Detailed Site Plan
Departure from Design Standards
Alternative Compliance
The Promise
Expedited Transit-Oriented Development Project

DSP-19071
DDS-685
AC-22002

STAFF REPORT

SUBJECT: Detailed Site Plan DSP-19071
Type 2 Tree Conservation Plan TCP2-036-2022
Departure from Design Standards DDS-685
Alternative Compliance AC-22002
The Promise - Expedited Transit-Oriented Development Project

LANDSCAPE AND AMENITY PLAN

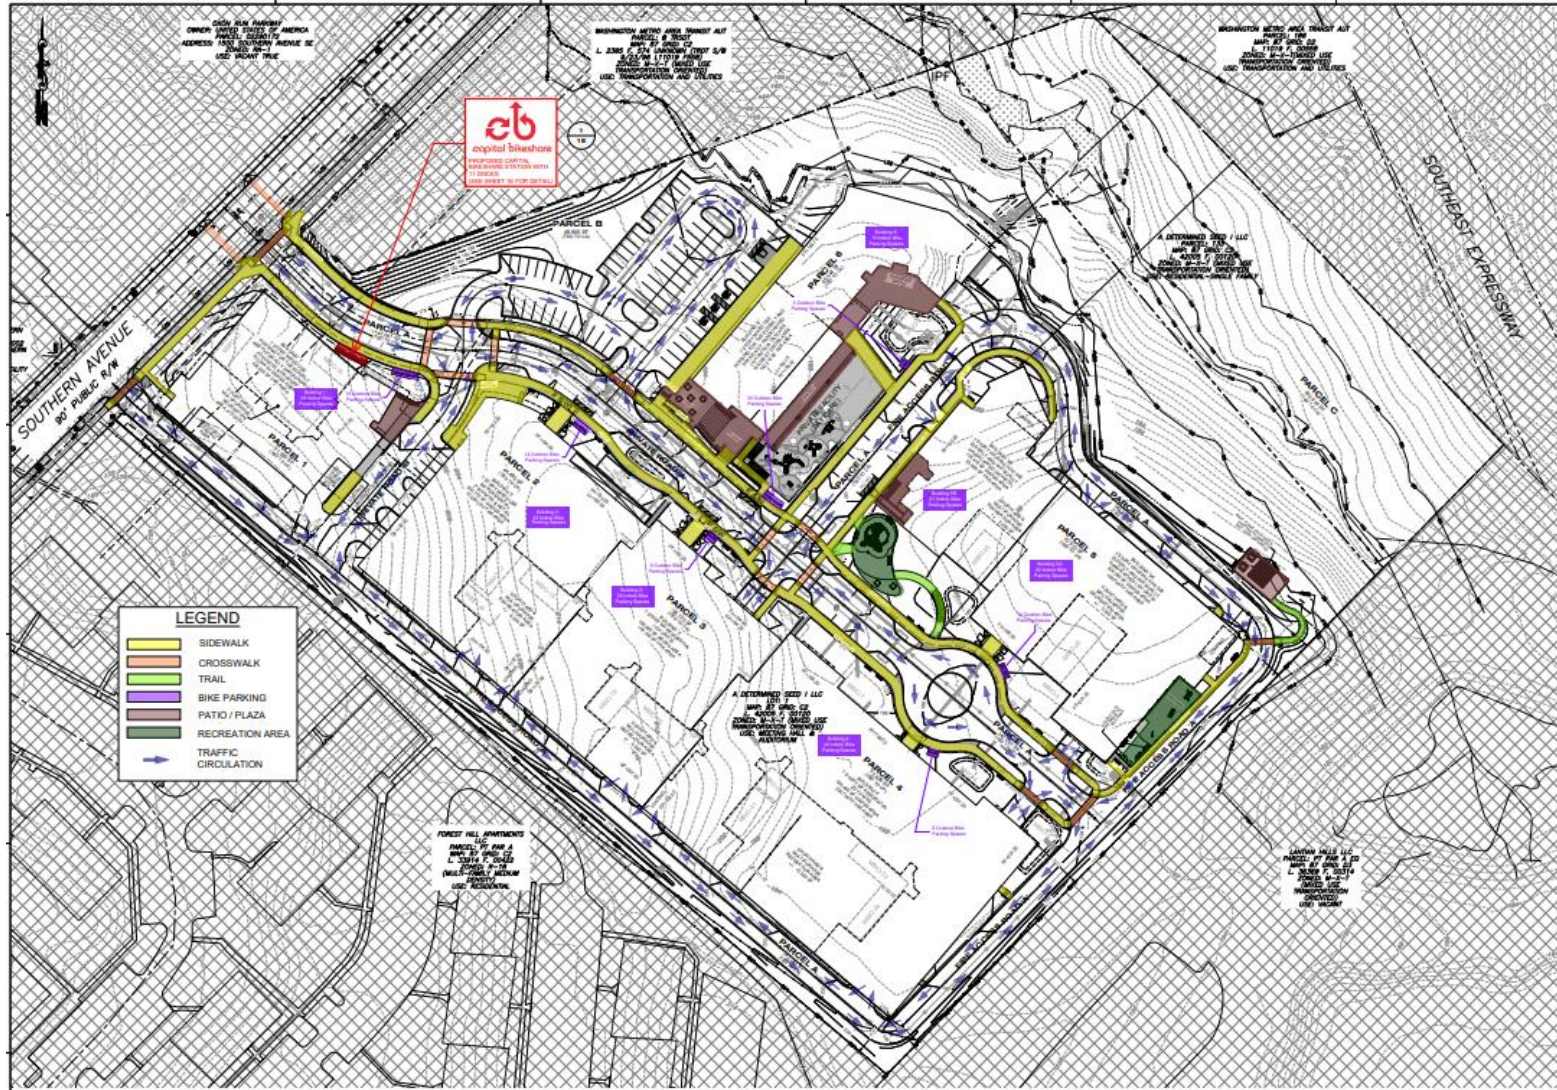
While the committee understands the special constraints created by the building’s placement and the location of the public utility easement along Southern Avenue, staff recommends that a minimum of six columnar evergreens be substituted for the shrubs adjacent to the building and retaining wall. Evergreen trees provide a greater number of planting units than shrubs and the replacement of shrubs with columnar evergreens will increase the total number of planting units. If replaced, the total planting units will be closer to the number of plant units normally required and the columnar habitat of these evergreen trees will provide a vertical accent. A condition is included herein, requiring the applicant to substitute the shrubs with columnar evergreens.
